Planning Application under Section 16 of the Town Planning Ordinance for Proposed Residential Institution (Student Hostel) at Middleton Towers, 140 Pokfulam Road (RBL No. 825 RP) (Application No. A/H10/98)
Submission of Responses to Comments (5th Batch)

Responses to Departmental Comments (5th Batch)

DRAINAGE AND SEWERAGE IMPACT ASSESSMENT

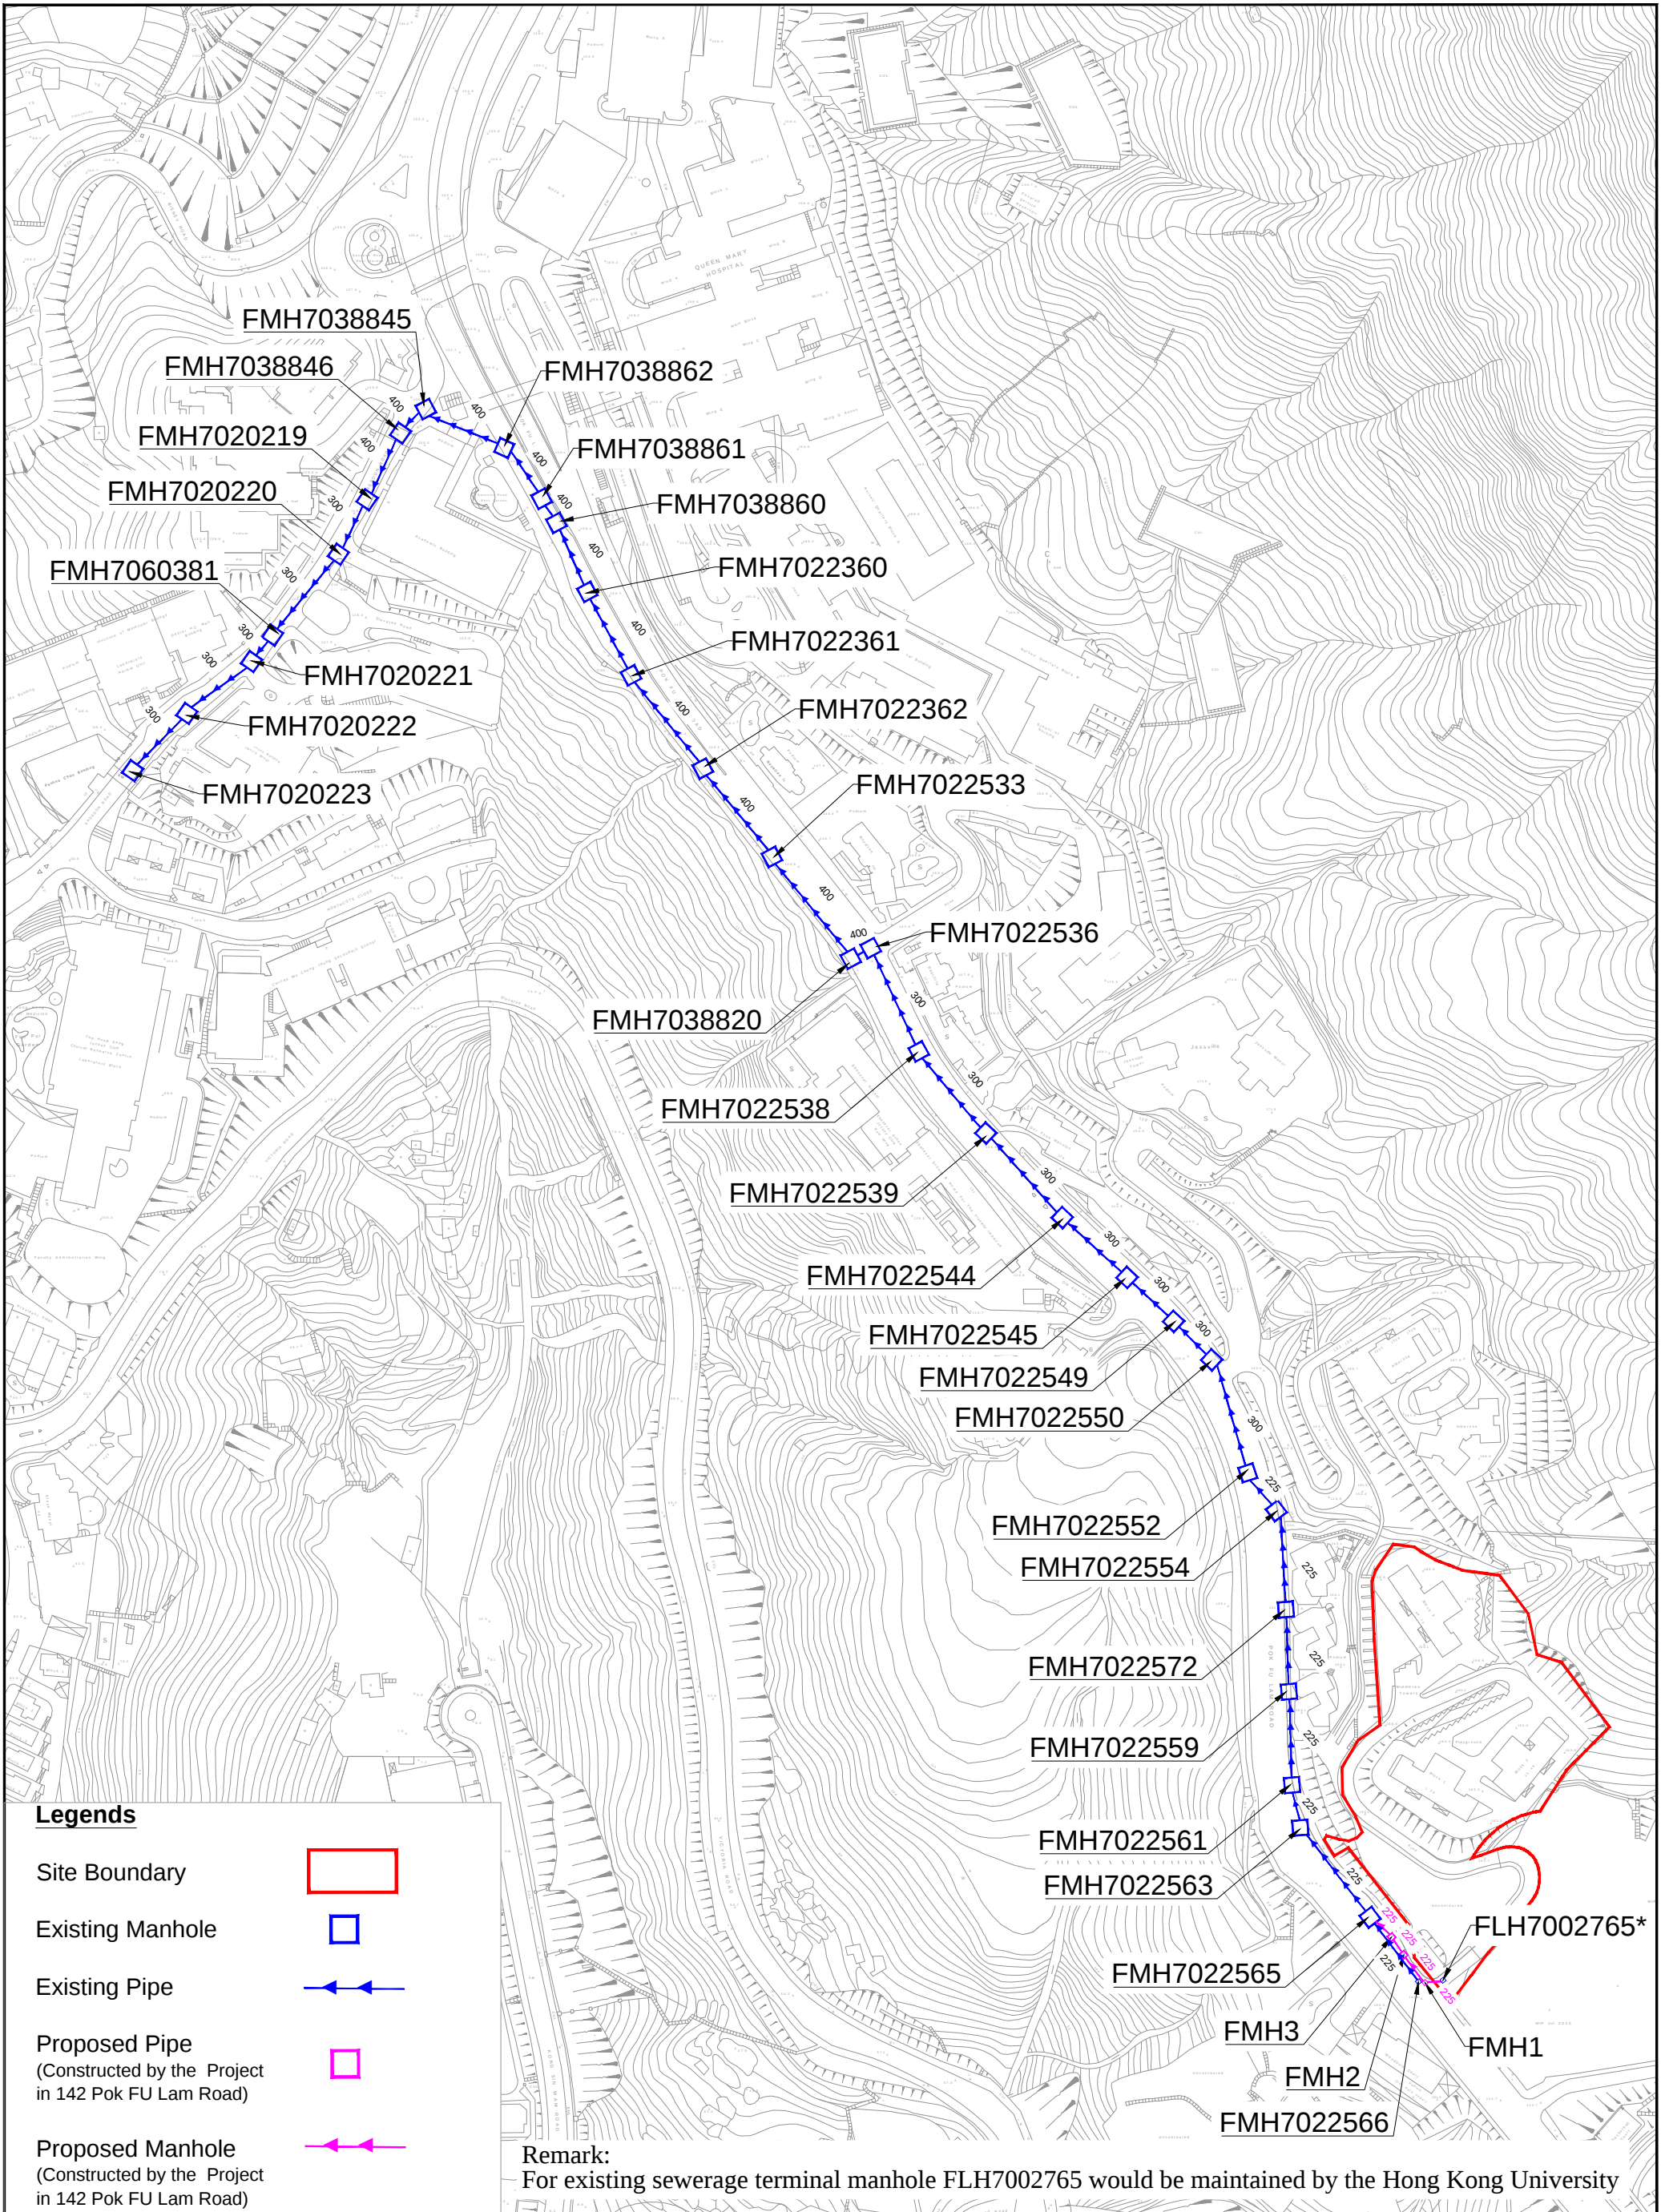
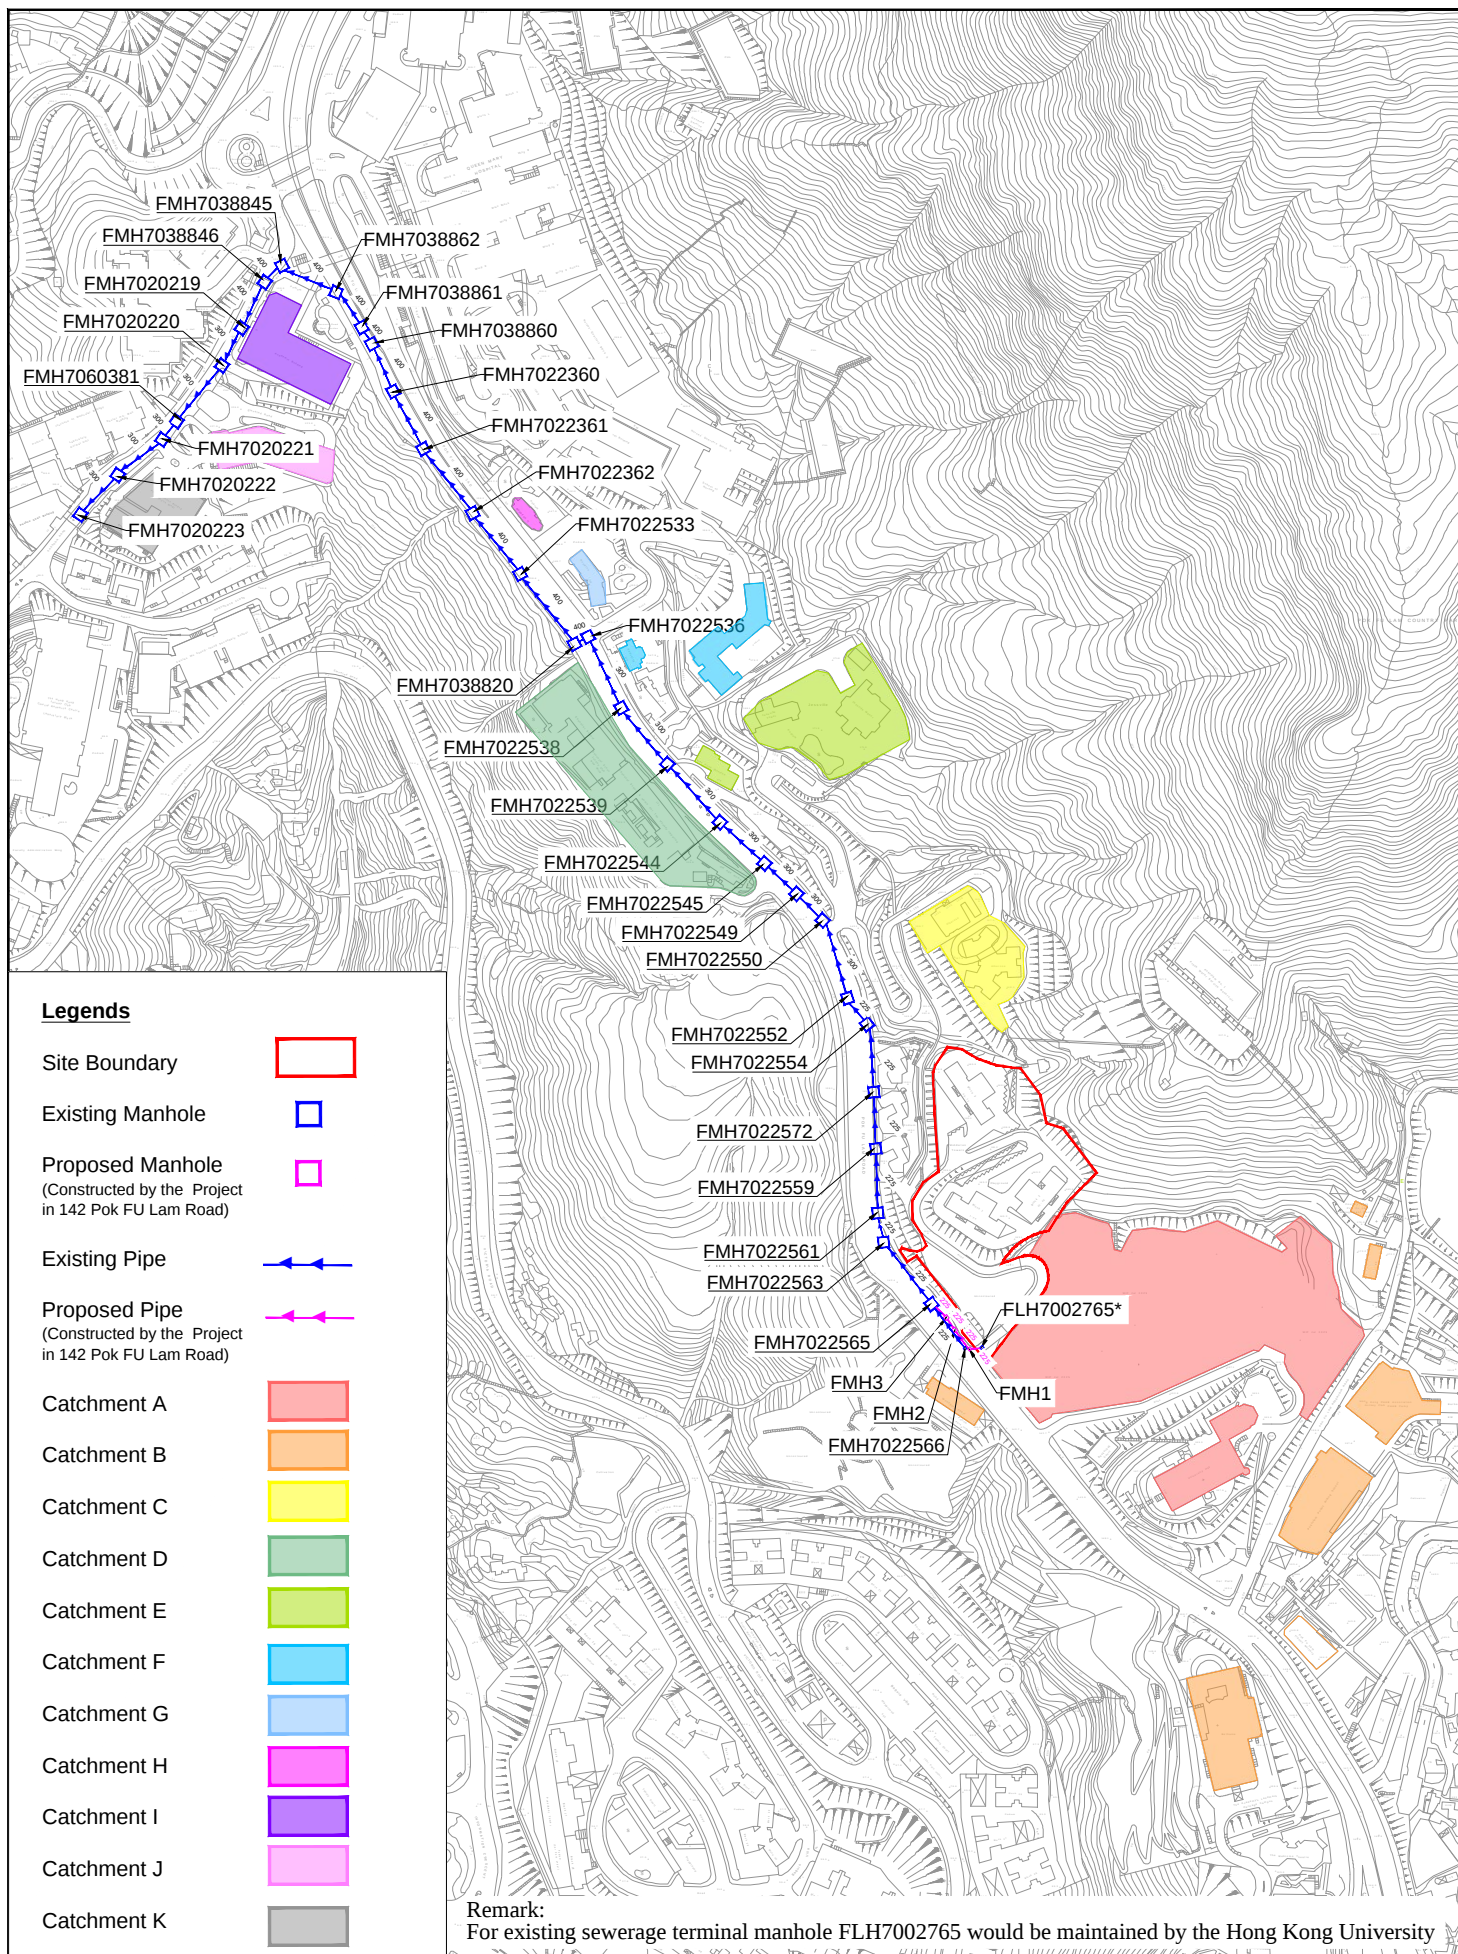
1.3.	Please revise the layouts according to the pdf "mark-up" for accurate and clearer presentation.	Noted and updated accordingly in Figure 2.1 to 3.2.
